Southern Nuclear Operating Company
Vogtle Electric Generating Plant Units 3 and 4
Request for License Amendment and Exemption:
Consolidation of Uninterruptible Power Supply System
Spare Battery Termination Boxes (LAR-15-004)

- Enclosures: 1) License Amendment Request, Consolidation of IDS Spare Termination Boxes (LAR-15-004)
2) Exemption Request for Consolidation of IDS Spare Termination Boxes (LAR-15-004)
3) Proposed Changes to Licensing Basis Documents (LAR-15-004)

Consolidation of IDS Spare Termination Boxes

(LAR-15-004)

UFSAR Tier 2 Figure 8.3.2-1, Sheet 2 of 2, Class 1E DC System One Line Diagram, excerpt from lower-center portion

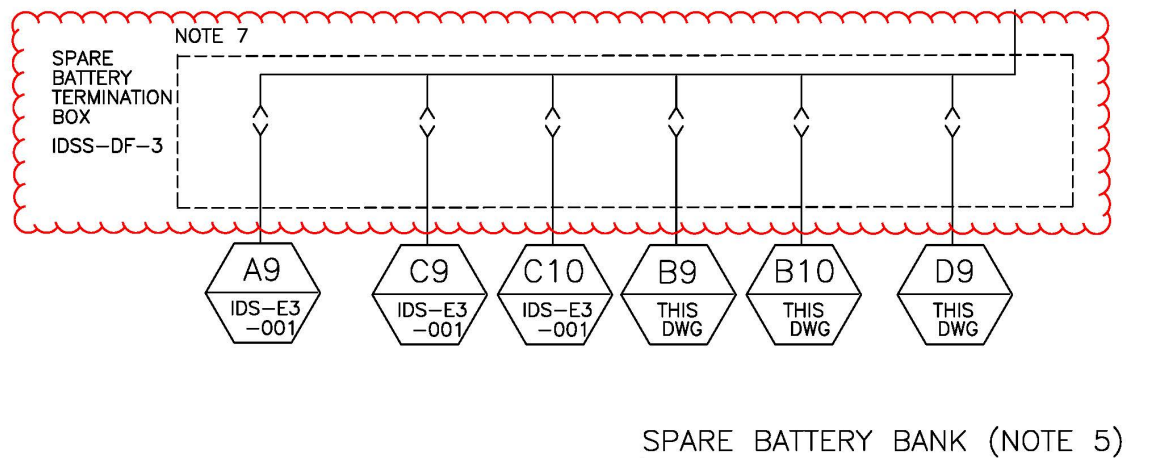
UFSAR Table 3.11-1 (Sheet 4), Table 3I.6-2 (Sheet 3), and Figure 8.3.2-1 (Sheet 2), are revised to replace the four Spare Termination Boxes with a single Spare Battery Termination Box.

Revise figure as shown below:
